Service Bulletin

Bulletin No.: 22-NA-024

Subject: Vibration, Hum or Drone Noise Heard from Front of Vehicle While Driving at Highway Speeds

Brand:	Model:	Model Year:		VIN:		Engine:	Transmission:
		from	to	from	to		
Chevrolet	Bolt EUV	2022	2022	—	—	All	All

5971991

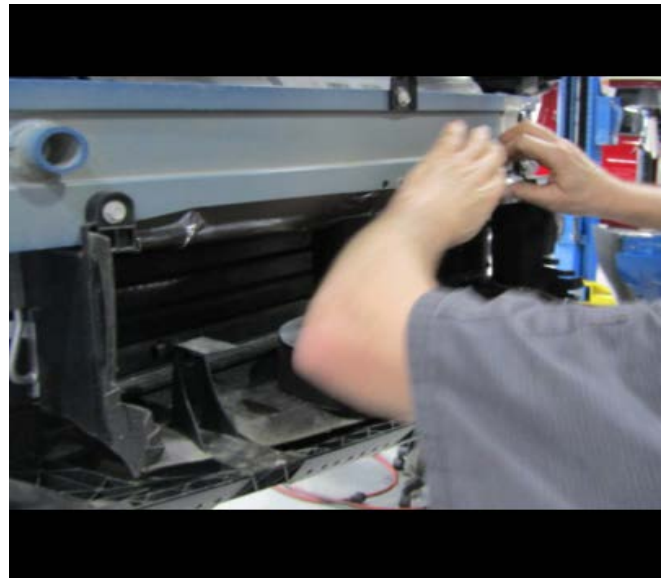
4. Pull forward the top of the radiator lower air baffle and position it away from the bumper beam.
5. Clean any dirt or residue from the top surface of the baffle.

5971997

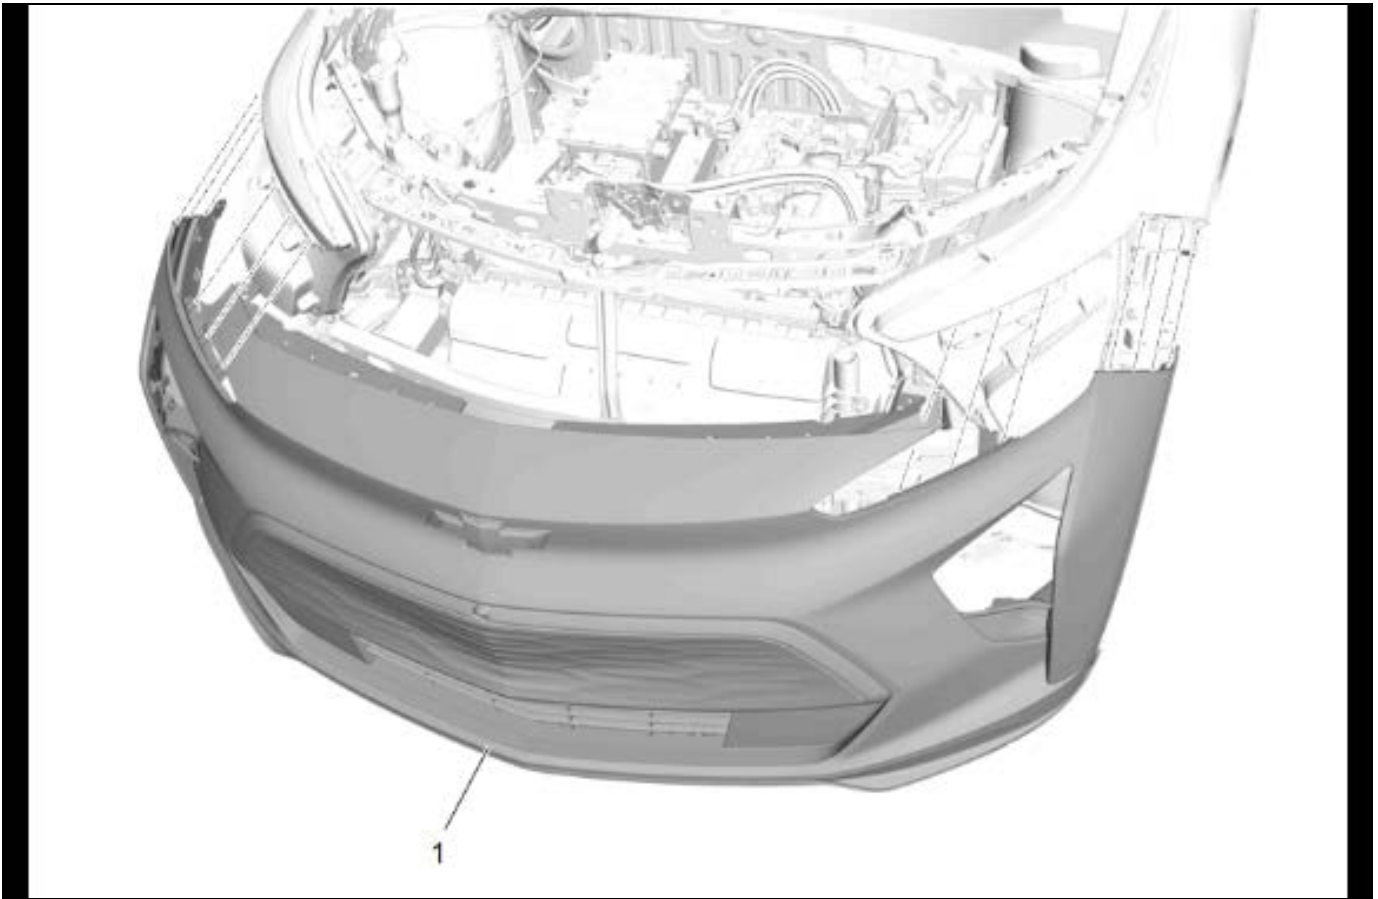
10. Reinstall the pedestrian sound alert speaker/ bracket (1), if removed. Refer to *Pedestrian Sound Alert Speaker Replacement* in the Service Manual
